**Integrated Urban Regeneration and Water Transport System (IURWTS), Kochi
Kochi Metro Rail Limited**

An Expanded Version of Notes Submitted Earlier (Final)

Agenda Item No.117.01. File No: 159/A1/2021/KCZMA, Nov. 8, 2021

Comments by C. P. Geevan, Member, KCZMA

Figure 3: IURWTS Canal Lock Gates (CLG) and Flood Risk Mapping of 2010 by KSDMA (shaded areas)

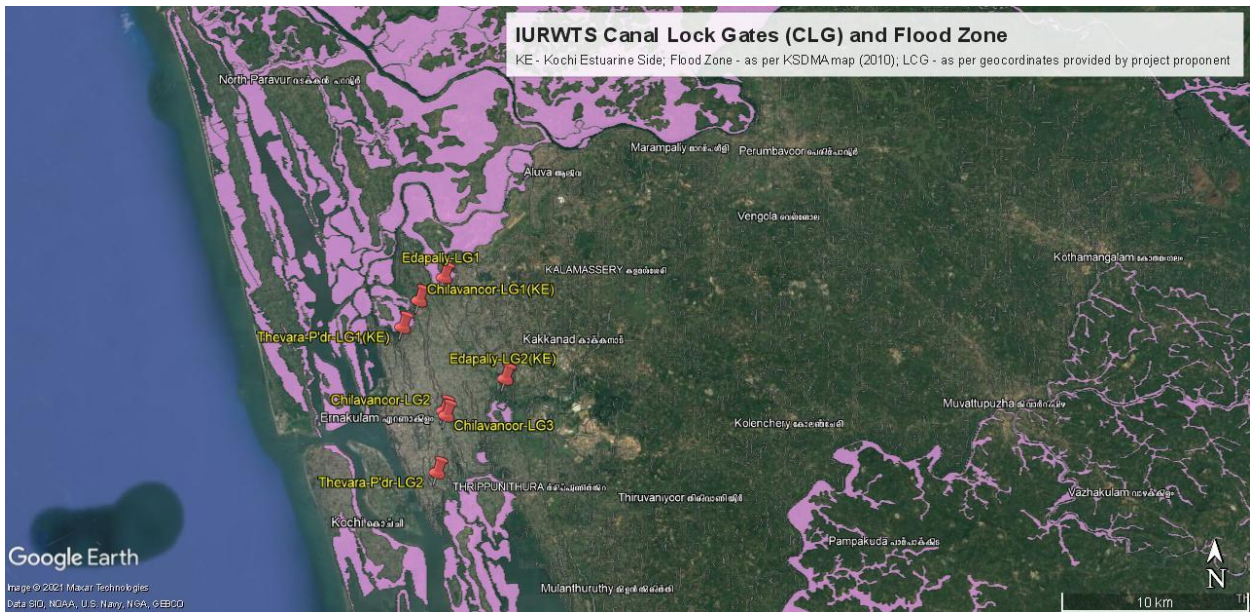
The With-CLG case requires somewhat elaborate discussion since the PP has confined all the HHFP studies to the inundation on the sides of the canal due to rainfall in the urban catchments of the canals. The very purpose of CLGs is to control inflows and outflows. Closure of CLGs on the northern ends blocks the inflow from the sub-basin outlets of catchments outside that of the canals. The closure of CLGs have considerable implications for those areas facing heavy rainfall and flows from flooded rivers. A look at Kerala State Disaster Management Authority's (KSDMA) flood risk map for the Ernakulam district will clearly show that while the areas covered by IURWTS are at low flood risk, the areas further north of the CLG on the northern ends of the canals are at exceptionally elevated risk. These will be apparent from a map of the region on which KSDMA's flood risk zonation and the location of CLGs are superimposed (Fig. 3).

It is obvious that the areas to the north adjoining the CLGs (northern ends) are at exceptionally high flood risk compared to the area covered by IURWTS. A closer look the map shows that the three major canals are important in easing the flooding from rivers on the northern areas (Fig. 4). Historically, all these canals were in a much better shape than they are today and could carry large amount of river discharges from the north to KE. It is these northern areas that are most affected by the flooding of the rivers not the areas covered by IURWTS. The extensive wetlands and drainage network to the south of the high flood risk areas are now degraded compared to the condition several decades ago due to draining of wetlands and loss of drainage network by rapid urbanisation. Flood management in the district requires an integrated approach in which all the major canals, the drainage network connected to them, and the remaining wetlands needs restoration.

Figure 4: Closer look at the CLGs and High Flood-Risk Areas, Ernakulam district (shaded areas)

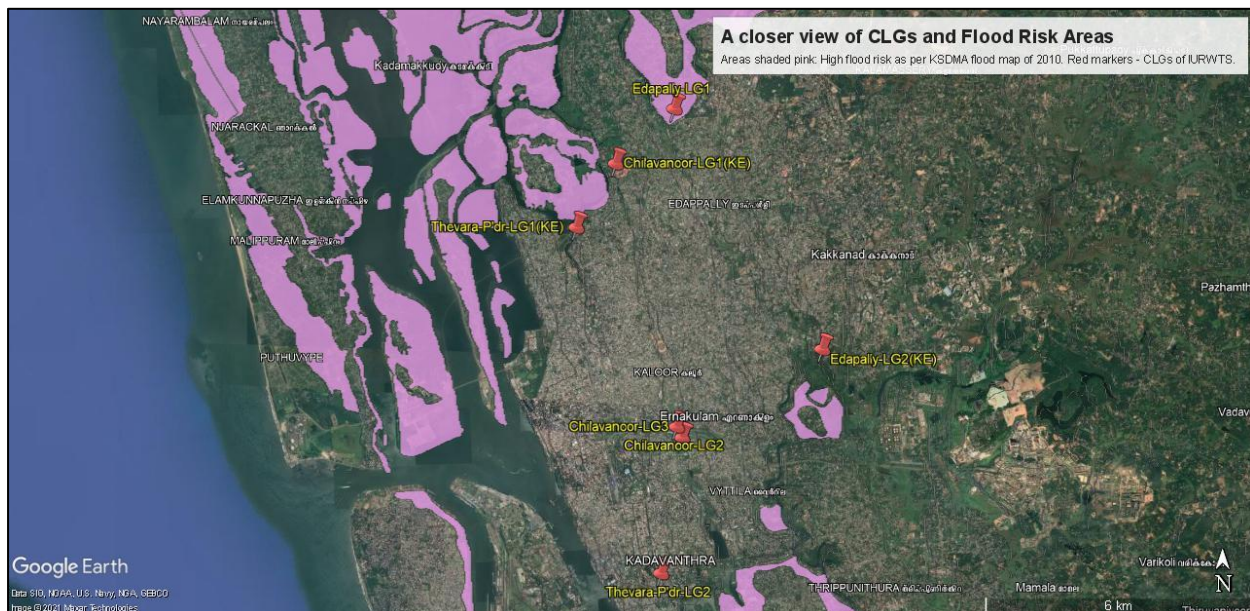
The above discussion shows that more than the water logging from rainfall in the urban catchments of the canals, flood management in the Ernakulam district must ensure that modifications in the drainage system anywhere do not aggravate the flooding in the northern parts where risk from river flooding is exceptionally high. Clearly operation of the CLGs have considerable impact on managing the flooding north of the CLGs of the three canals shown in the figures 3 and 4. The situation will be clearer if we consider the Edappally canal and its CLGs (Fig. 5, 6).

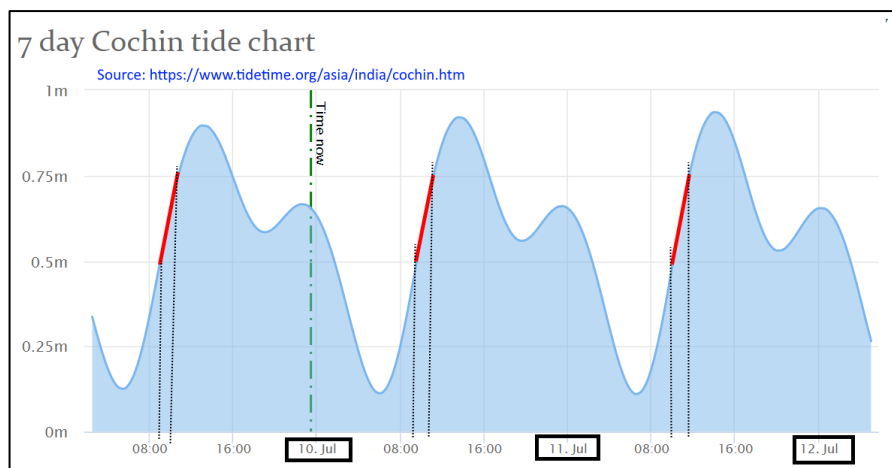
A large outflow is not realistic because the effective outflow during the rising tide will depend on the difference in the outflow from the canal and the powerful tidal influx. The duration of rising tide above +0.5 m is short. From the

tide charts (see figure), we can see that usually in a day, the duration of flood tide from +0.5 m to +0.75 m is about 90 minutes. There will be outflow only if the net outflow (out flow from canal less tidal inflow) is positive in this short portion of the flood tide. While the quantitative estimates of the volume of exchange under different scenarios of tidal action must be computed, it is obvious that the effective outflow in such a short period would be a tiny fraction of the total volume of water in the canals maintained at a minimum depth of about 1.6 m.
